ADDENDUM NUMBER ONE

DATE: October 16, 2012

SUBJECT: Addendum Number One to
Manchester Road Streetscape Project Phase 2
Federal Project No. STP-5401(662)
Cochran Project No. SC10-229

Install W.O. 67209
Abandon W.O. 58719

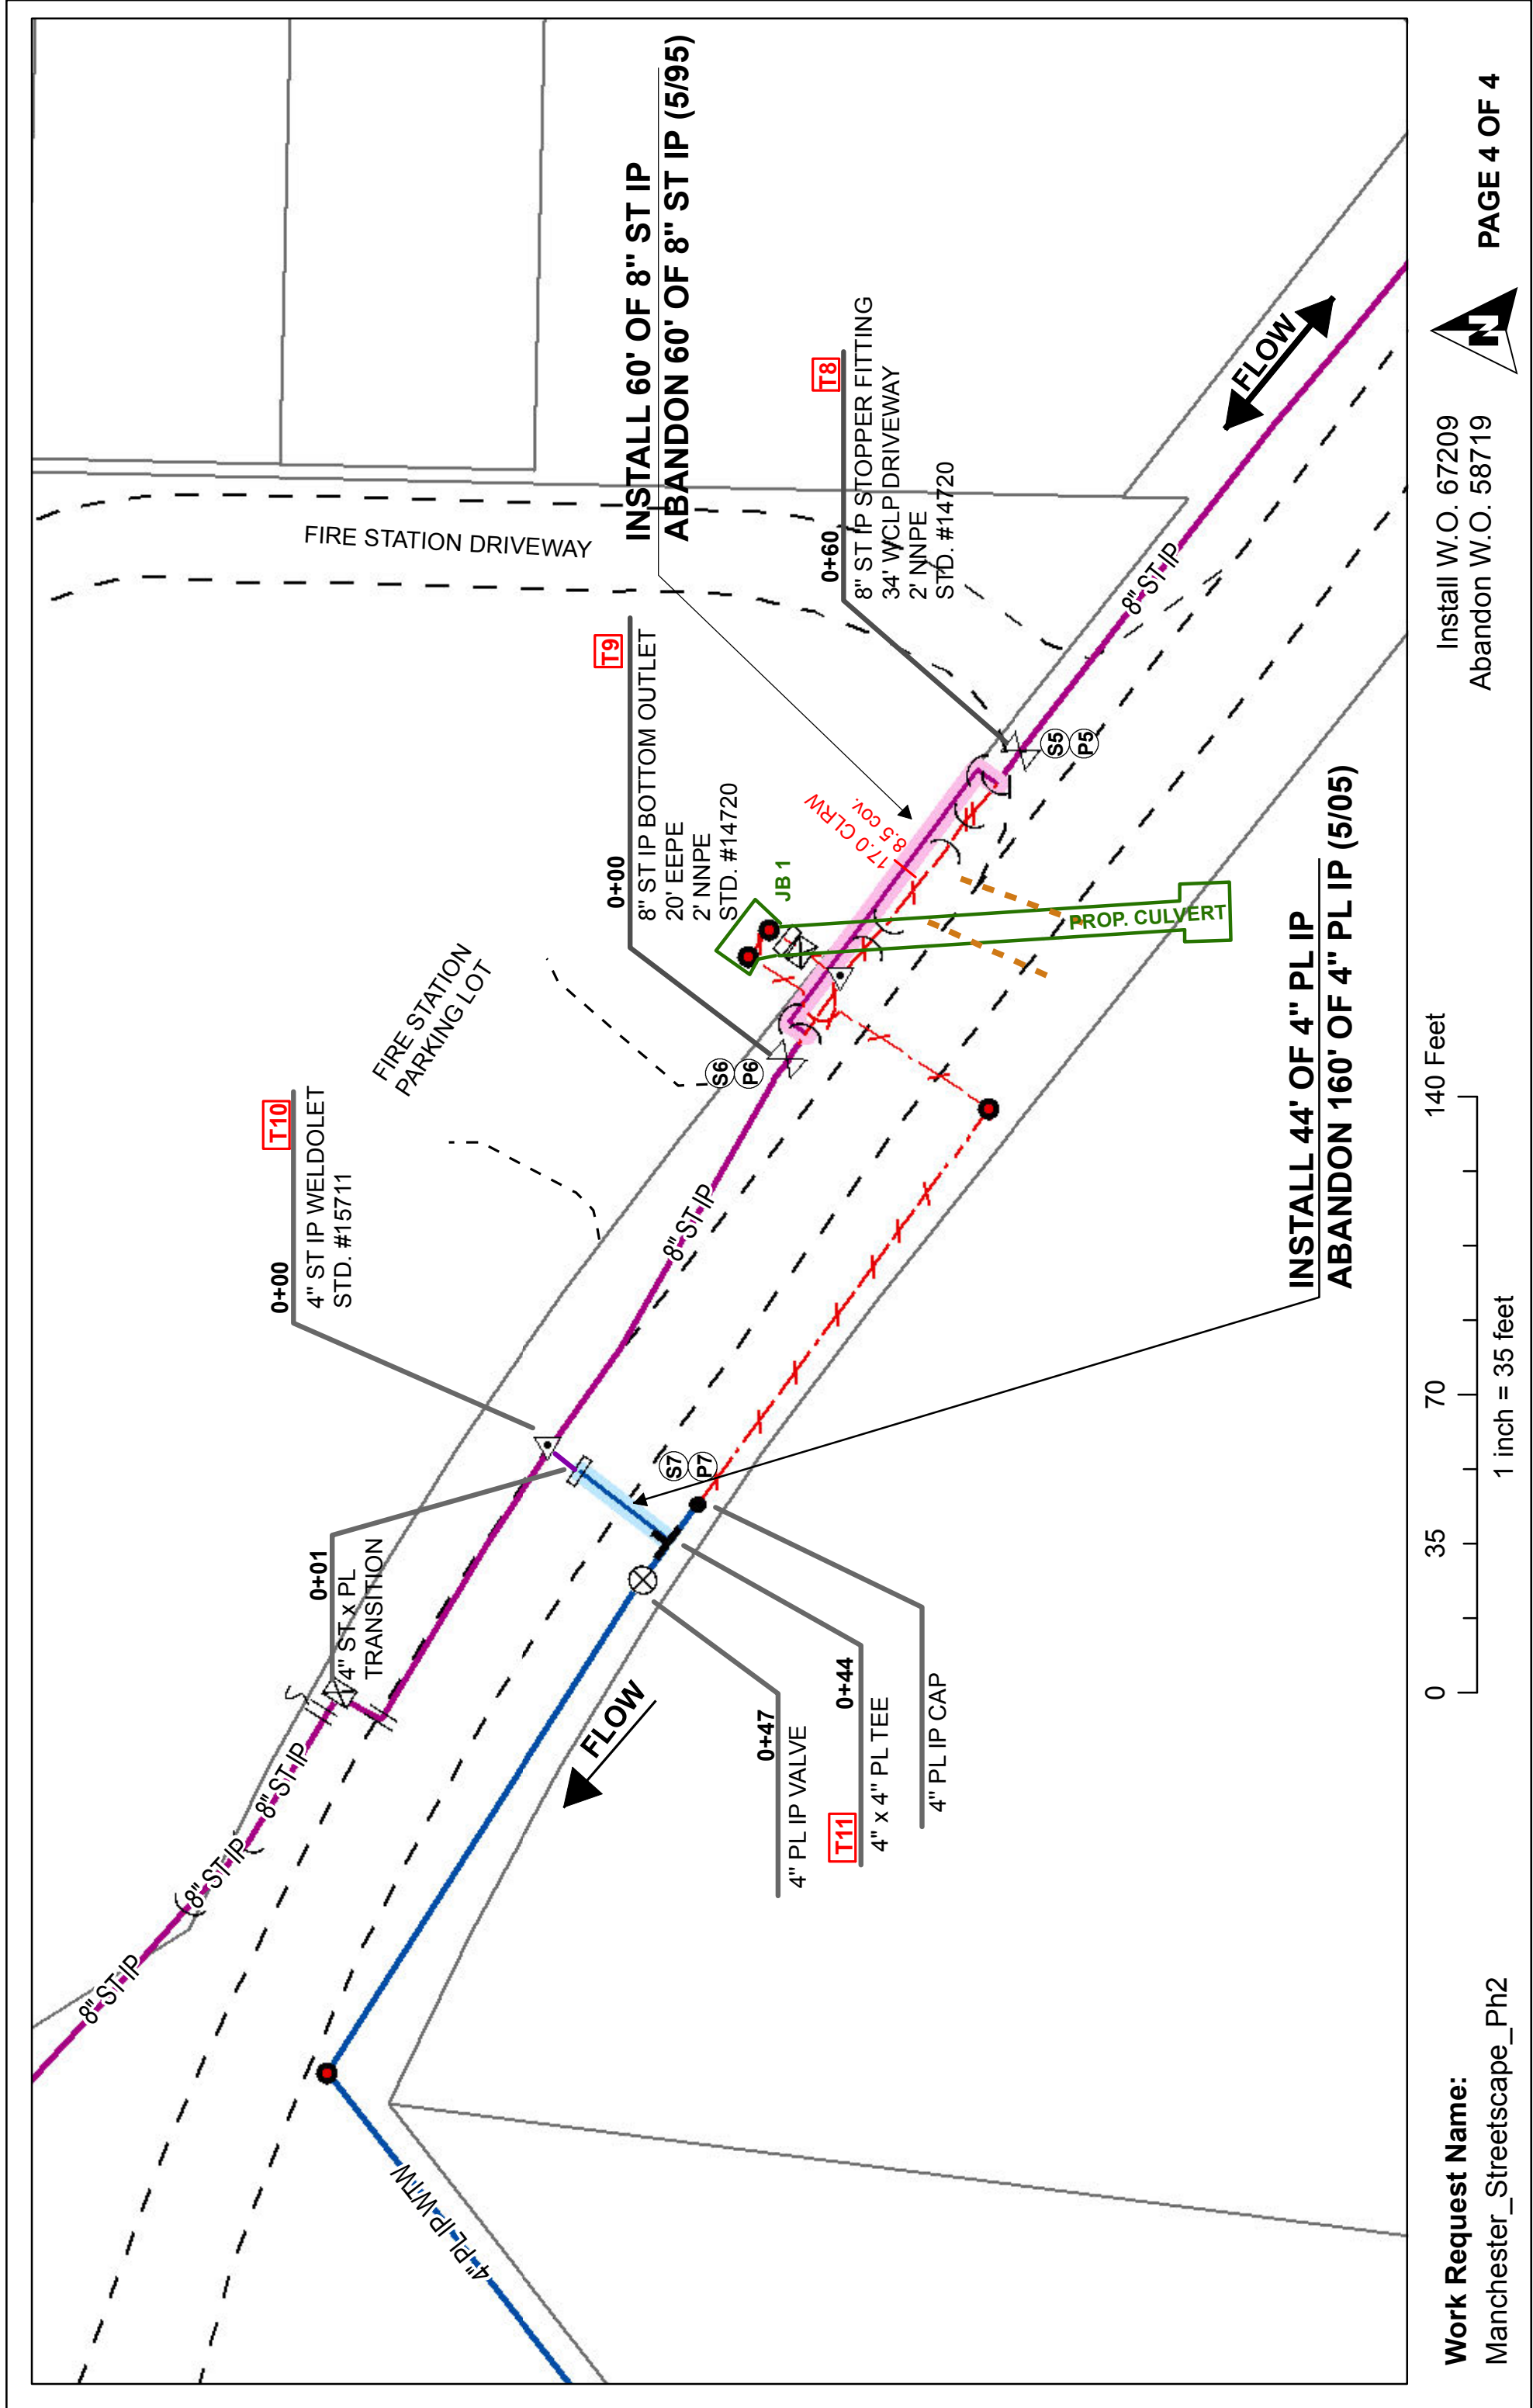
6. **CLARIFICATION:** On plan sheet ST-2, Storm Line 4 notes that the Contractor is to relocate the existing gas line. Laclede Gas will be responsible for moving all gas line conflicts. A copy of the Laclede Gas relocation plan has been included for informational purposes. Delays due to gas line conflicts are addressed in the Job Special Provisions.

INSTALL 20' OF 8" ST IP, LOWER 3'
ABANDON 9' OF 8" ST IP (5/95)
